BULLETIN

SUBJECT: Winterization of J3C-65

MODELS AFFECTED: J3C-65 Airplanes

FIG I

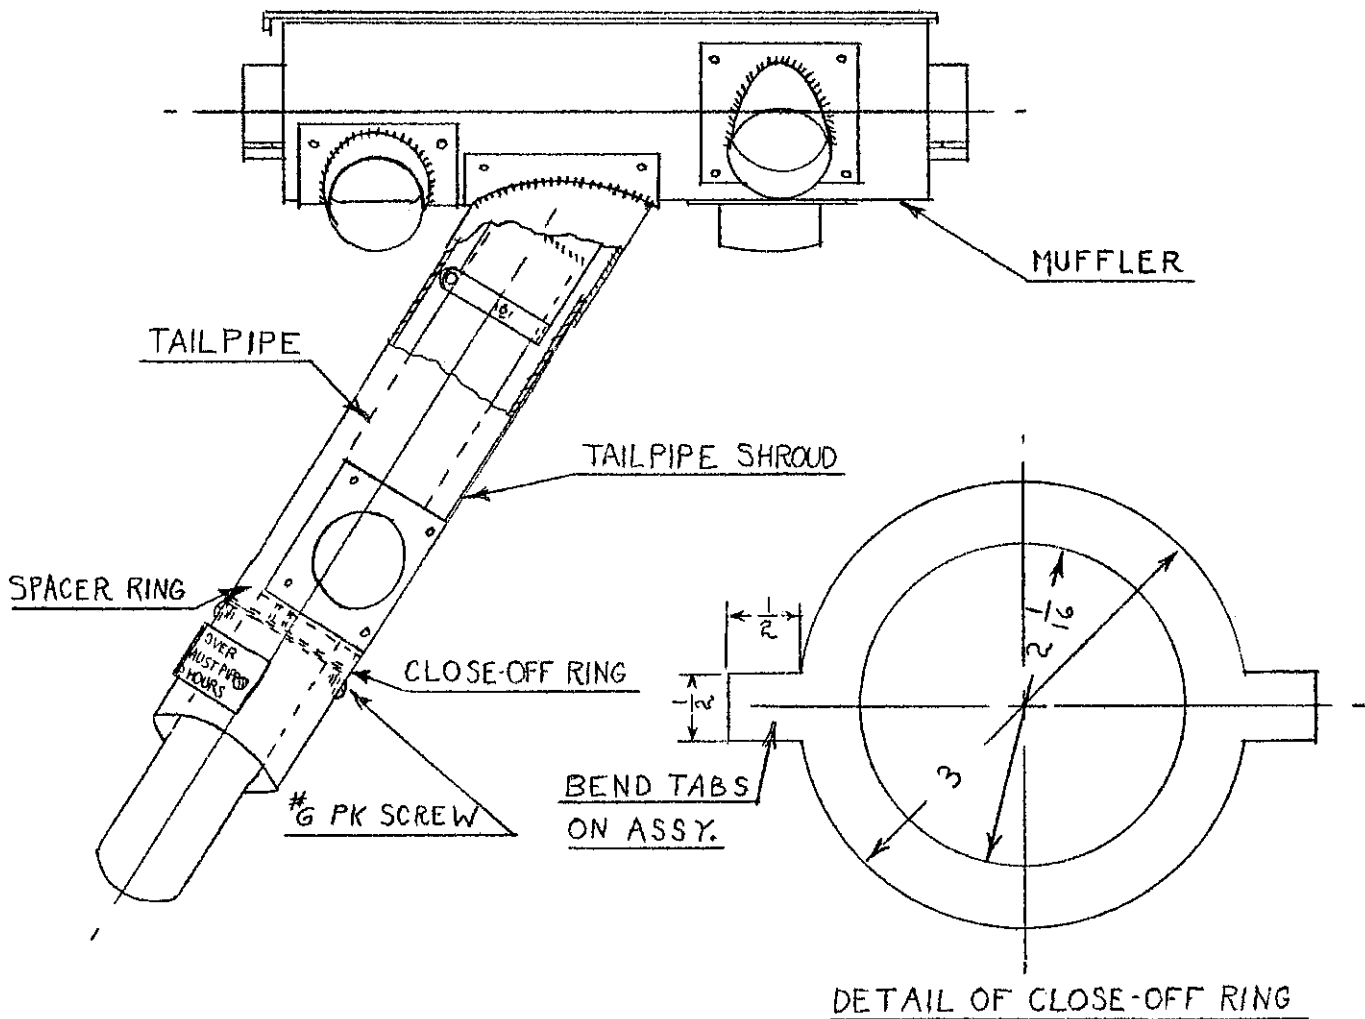
1. All J3C-65 airplanes, with muffler installation, up to serial number 15396.
 - a. The aluminum breather tube (Part No. 84332) can be lagged with 1/16" to 1/8" felt or some similar material which should extend all the way to the bottom of the tube.

- b. To obtain a higher operating oil temperature, it is permissible to lag the oil sump with waterglass and flake asbestos or some similar material which will keep the cold air off the sump and hold the heat in. A material thickness of 1/16" to 1/8" is satisfactory for this lagging.

- c. The cowl air inlet opening, the first opening under the propeller hub, should be closed. Piper Part 73951 is a cover plate for this opening.
 - d. In order to insure the highest possible carburetor heat rise, the flat plate valve in the carburetor air box should be checked to see if it is seating properly. This can be done easily by removing the air filter and observing the top edge of the valve, with heat on. The valve should seat flush with the top of the box, with absolutely no air gap.

- e. The tailpipe shroud assembly (Part No. 70912) can be lagged with asbestos or some similar fireproof material. The recommended thickness of this material is approximately 1/16".

f. The flexible tube which runs from the tailpipe shroud to the carburetor air box can also be lagged with the same material as used on the tailpipe shroud.

g. See Figure I.
